DA2018/1067

89 WOORARRA ROAD – ELANORA HEIGHTS, NSW 2101

ARBORICULTURAL REPORT

File No: 0224

Figure 1: Showing Front fence proposal

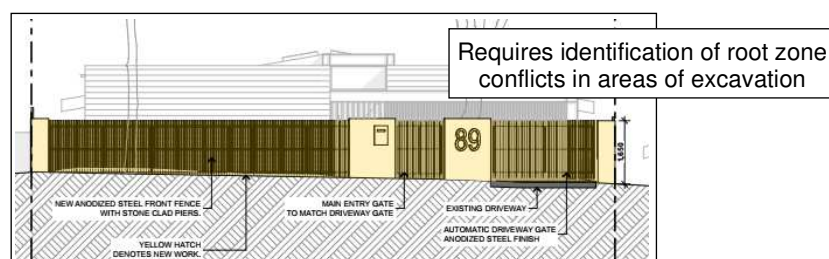
1. Trees numbered T2, 3, 4, 5 & 6 noted within Survey Plan documentation have not been site inspected or assessed as part of this proposal. Tree data is based on Survey Plan documentation for Structural Root Zone (SRZ) radiuses described as:
 - T2: trunk 300mm(Ø) having an SRZ of 2.1m
 - T3: trunk 500mm(Ø) having an SRZ of 2.6m
 - T4: trunk 300mm(Ø) having an SRZ of 2.1m
 - T5: trunk 400mm(Ø) having an SRZ of 2.4m
 - T6: trunk 300mm(Ø) having an SRZ of 2.1m
2. Based on the front fence being located within the SRZ of the trees including T9 tree root investigations are required where any excavation for pillar / post supports are required as to identify the location, distribution and impacts to critical underlying tree roots. Any area of cut should also be clearly detailed, with the front fence panel sections supported above ground level to minimize impacts within the SRZ & TPZ.

Figure 2: Showing minor addition to garage

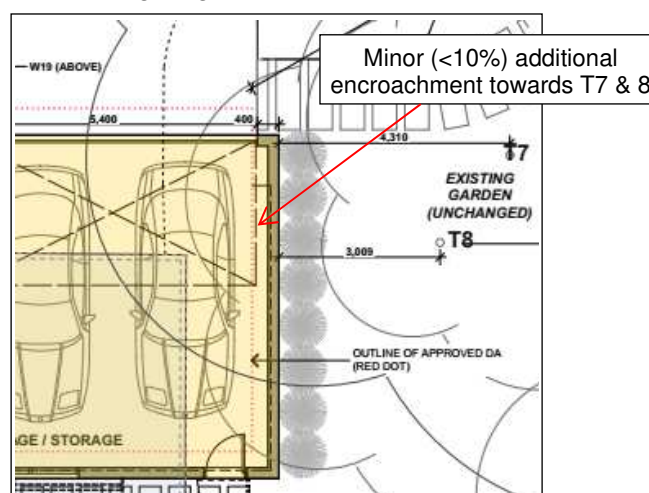
3. Trees 7 & 8: Ground Floor Plan A.04 shows a minor increase in the garage footprint with proposed outside the SRZ. Additional impacts within the TPZ are likely to be *Minor*, (<10%) disturbance indicating the trees are capable of being managed in accordance with previous DA approved recommendations, and/or as indicated within Appendix- A: *General tree protection requirements*; specific to:
 - Project arborist supervision & certification during manual excavation within tree protection zones. Exposed roots are to be certified as managed in accordance with AS4970 – 2009 Section 4.5.4 *Root protection during works within the TPZ*, such that tree roots are not damaged or ripped beyond the point of excavation by site machinery.

Figure 3: Showing access with least conflict to trees

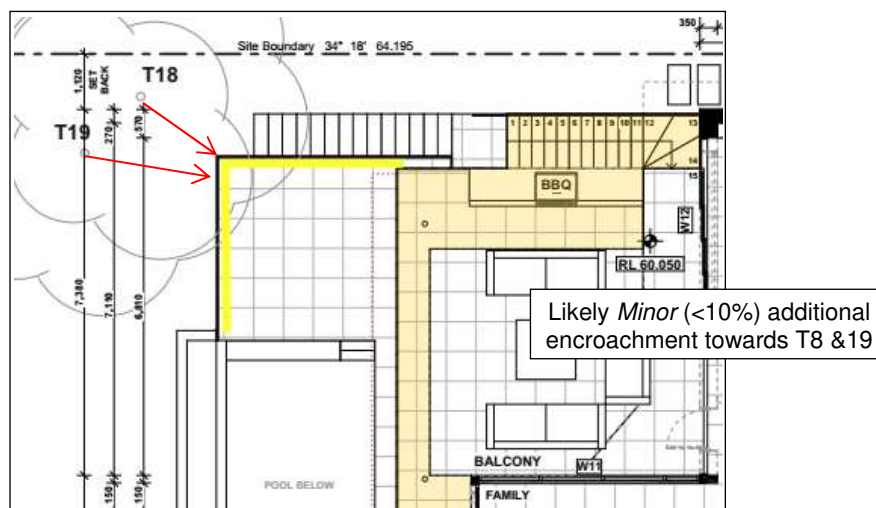
3. Trees 18 & 19: Ground Floor Plan A.04 indicates the proposed setback to T18 is located outside of the SRZ, at or near 2m from the tree and T19 where desk top information indicates a likely *Minor* (<10%) disruption within tree protection zones.

Given works are likely located outside the SRZ with likely *Minor* (<10%) TPZ disturbance the trees are capable of being managed in accordance with previous DA approved recommendations, and/or as indicated within Appendix- A: *General tree protection requirements*; specific to:

- Installation & certification of appropriate tree protection fencing.
- Project arborist supervision & certification during manual (hand) excavation within tree protection zones. Exposed roots are to be certified as managed in accordance with AS4970 – 2009 Section 4.5.4 *Root protection during works within the TPZ*, such that tree roots are not damaged or ripped beyond the point of excavation by site machinery.
